Re: Application for Comprehensive Permit – 57 Perkins Row, Topsfield

RE: Perkins Landing, 57 Perkins Row, Topsfield, MA

**Subject: 57 Perkins Row, Topsfield, MA
Proposed 40B Project**

To: Daniel C Hill, Esq., Hill Law
From: David Black
Date: August 23, 2021
Subject: Proposed Residential Development
57 Perkins Row, Topsfield, MA
Traffic and Transportation Review

Figure 3 - Proposed Stormwater Recharge System #2

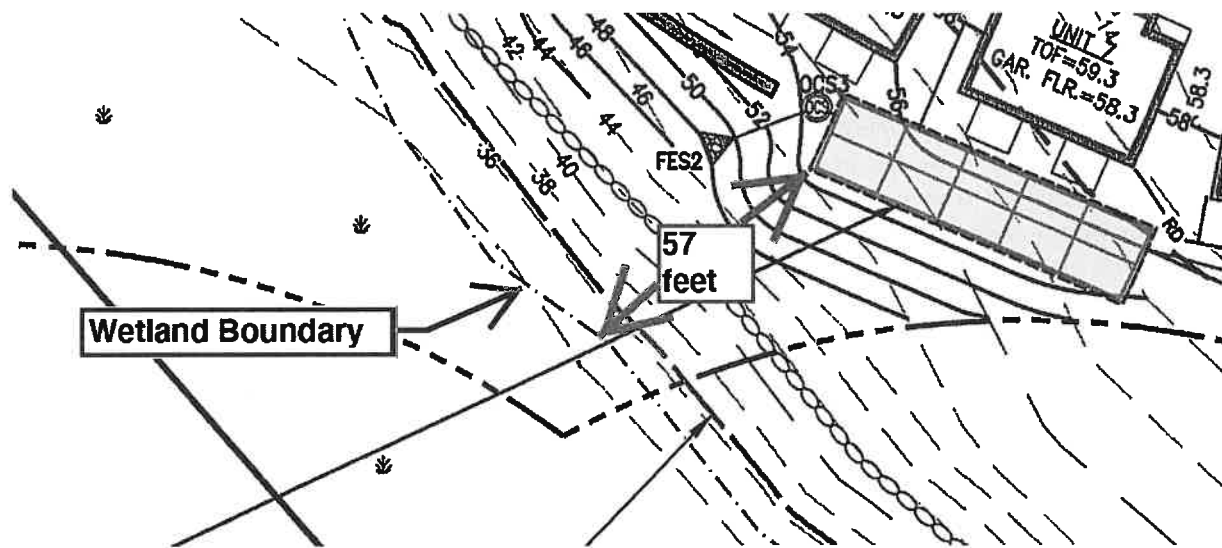
Recharge system #2 is located approximately 57 feet from the wetland boundary (see figure 3). According to the groundwater mounding analysis provided in the Technical Report, this recharge system will raise water levels in the adjacent wetland by approximately 0.5 feet or 6 inches (see figure 4). Please note that this groundwater mounding analysis includes the non-conservative input values of saturated thickness and permeability (discussed above).

Figure 4 - Groundwater Mounding Analysis for Stormwater Recharge System 2 (Technical Report - page 118)

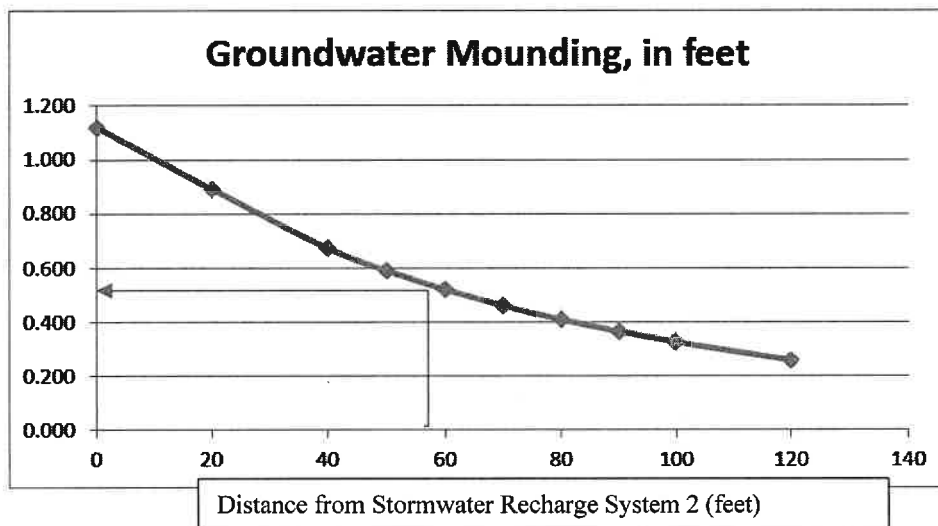
MADEP Stormwater Handbook, Volume 3, Chapter 1, page 28 provides criteria by which to evaluate groundwater mounding impacts on wetlands. It states, **“The mounding analysis must also show that the groundwater mound that forms under the recharge system will not break out above the land or water surface of a wetland (e.g., it doesn't increase the water sheet elevation in a Bordering Vegetated Wetland, Salt Marsh, or Land Under Water within the 72-hour evaluation period)”**.

Figure 2. Wetland crossing at entrance. Note proposed box culvert, retaining walls and wetland mitigation area, all beside or surrounding the PVP.

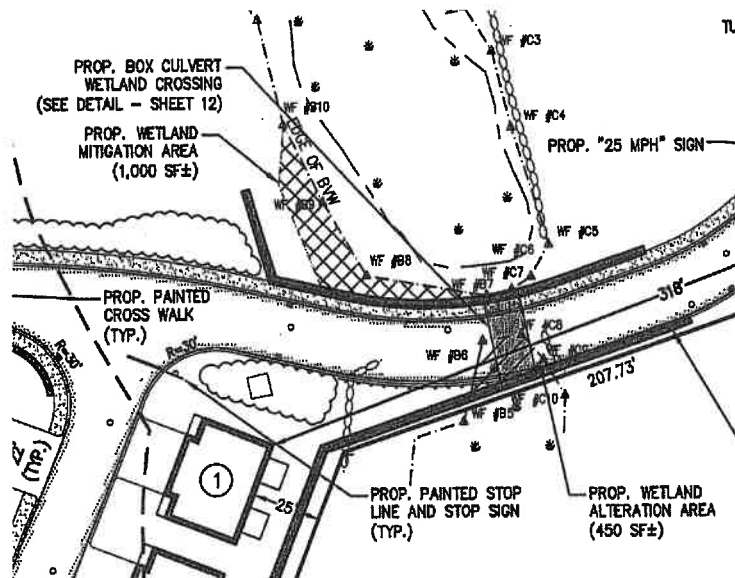
The PVP lies within a 100-foot buffer zone to BVW. Any activity within that zone has the potential to alter the PVP. In the case of this project, an entrance road to the development comes within five feet of the PVP edge. More egregious, a retaining wall for the road is proposed to be built directly beside the PVP edge, restricting and/or eliminating all wildlife passage where the wall is constructed.

MassDEP regulations require that any BVW lost be replicated. In this case, the roadway crosses over BVW as it passes by the PVP, eliminating some 450 square feet (s.f.). To compensate for the loss, the Plans indicate that 1,000 s.f. of BVW replication will be built directly beside the western edge of the PVP. This area of replication, typically protected by silt fence, again restricts wildlife passage into and out of the PVP, potentially altering the habitat viability of the PVP itself.

Further, the Plans call for installation of a new six-foot tall by 12-foot wide box culvert to replace an existing smaller culvert. Plans do not indicate the dimensions of the existing culvert, but if the volumetric capacity and velocity potential of the new culvert exceeds that of the existing device, flows into or out of the PVP may be substantially altered, thus altering the existing hydrology of the PVP. The Plans do not provide such an analysis. Such data must be analyzed to ensure that major hydrologic changes do not occur to the PVP — and to ensure that volumetric increases in flow do not occur onto adjoining properties.
